Amendment under 37 CFR 2.101
Application No. 10/807,327
Attorney Docket No. 042271

REMARKS

EXPLANATORY FIG. B

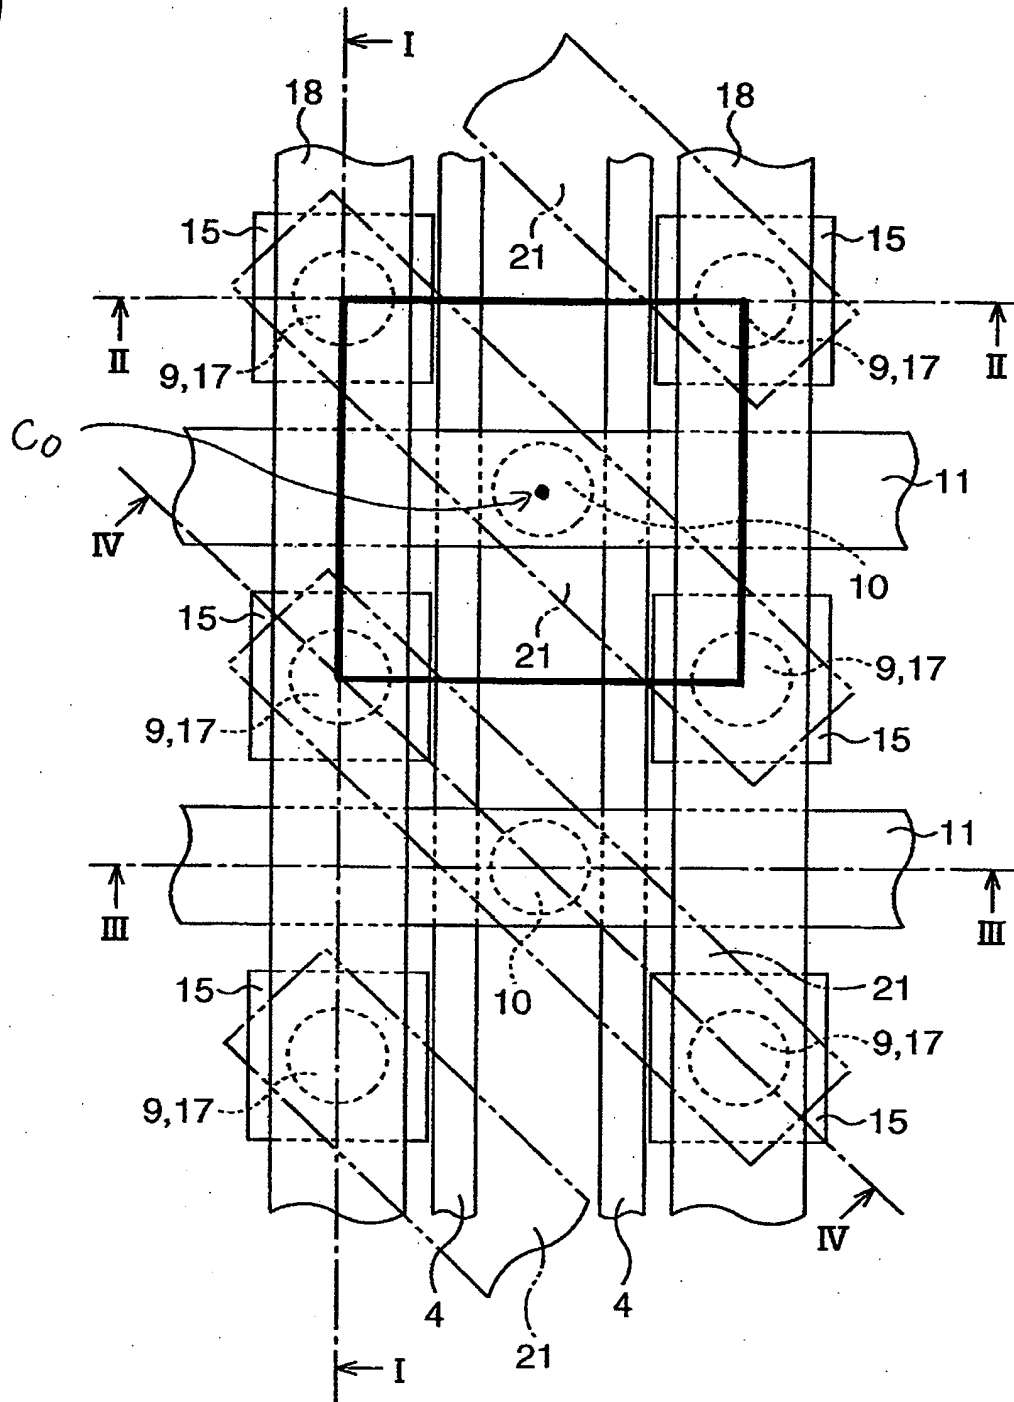
In so doing, the Examiner alleged that Applicant's Prior Art discloses all recitations in claim 2 including "wherein the second contact plug is substantially located in a center of an area surrounded by **four closest ferroelectric capacitors** out of said plurality of ferroelectric capacitors" referring to Fig. 10.

On the other hand, in the related art shown in Explanatory Fig. B (corresponding to Fig. 10), the area enclosed in the bold line corresponds to "an area surrounded by four closest ferroelectric capacitors . . ." in claim 2. The center C_1 of the enclosed area corresponds to "a center of an area . . ." in claim 2. However, as shown in Explanatory Figure B, the contact plug 60 does not position at the center C_1 .

However, in Fig. 10, for example, the second contact **plug 60 is not** substantially located **in a center of an area surrounded by four closest ferroelectric capacitors**. Thus, Applicant's Prior Art does not disclose "wherein the second contact plug is substantially located in a center of an area surrounded by four closest ferroelectric capacitors out of said plurality of ferroelectric capacitors."

Thus, there is clear difference between the present invention as recited in claim 2 and the structure shown in Fig. 10.
